TYPE NO CV7200 – CV7300	TYPE Coffe Vending Machines	T.I. NO 02 - 2015				
SERIAL NUMBERS AFFECTED From and including S/N 42411444		ISSUED BY Documentation/N&W Valbrembo				
SUBJECT NEW PELTIER CELLS		ISSUED FOR (X): <table border="1"> <tr> <td>Action</td> <td></td> </tr> <tr> <td>Information</td> <td>X</td> </tr> </table>	Action		Information	X
Action						
Information	X

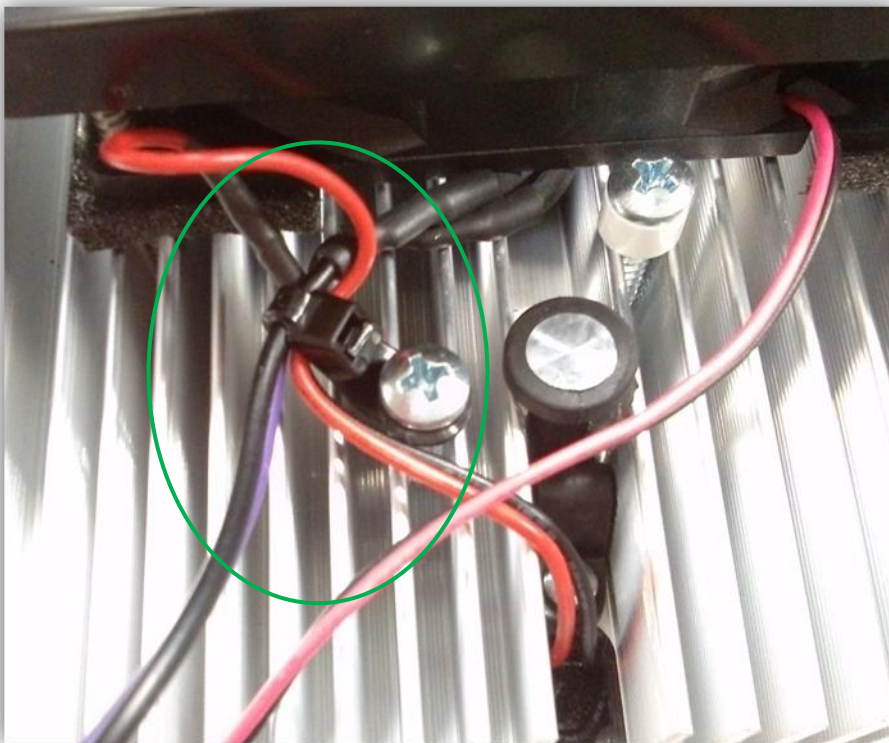
1. In the existing “Peltier cells” the rubber caps, used to cover the screws head (see pictures below), can’t avoid the condensation accumulation over the screws head.
2. Furthermore it’s necessary an improvement of the wiring fixing.

1. So to prevent a damage and consequently a complete failure of the cells, a new improved rubber cap has been introduced.

2. Below a photo of the improved wiring fixing.

3. A self adhesive foam insulating layer (5) is glued on the basic plate of the heat sink of the new cooling device.

The new “Peltier cells” solution can be installed in the machines prior to the above mentioned serial number (back compatibility)
